PRODUCT/PROCESS CHANGE NOTICE (PCN)

PCN #: **L-0405-04** DATE: 5/19/2004
 Product Affected: VFQFP (NL/NLG28/40/52/56/68)
 packages shipped in Tape and Reel
 Date Effective: 6/18/2004

ATTACHMENT - PCN #: L-0405-04

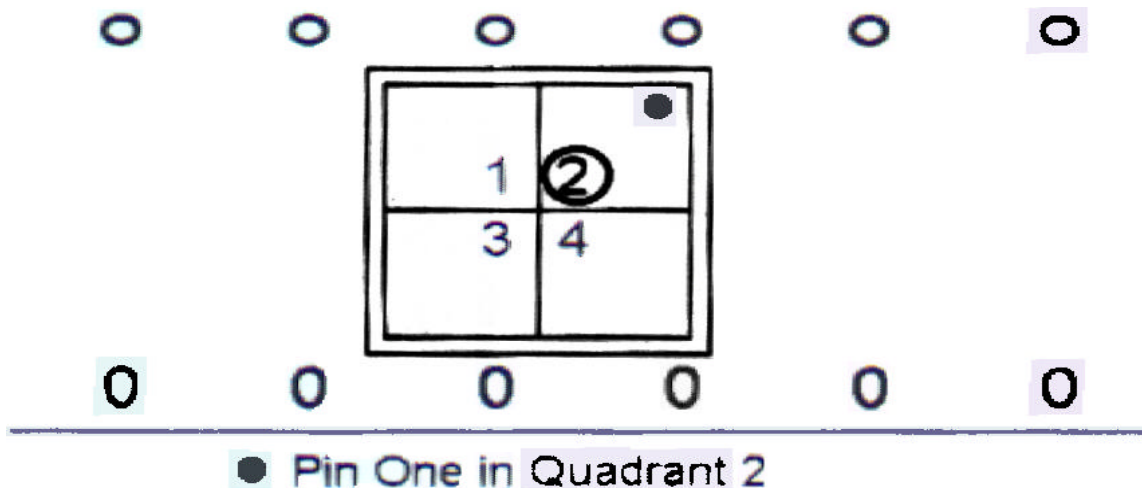
PCN Type: To comply to current EIA Standards (EIA-481-B) requirement.
Data Sheet Change: No
Detail of Change: This change will be implemented on all VFQFP packages.

Additional label will be placed on the intermediate box (pizza box), reel and ESD/moisture barrier bag to alert customer of this change.
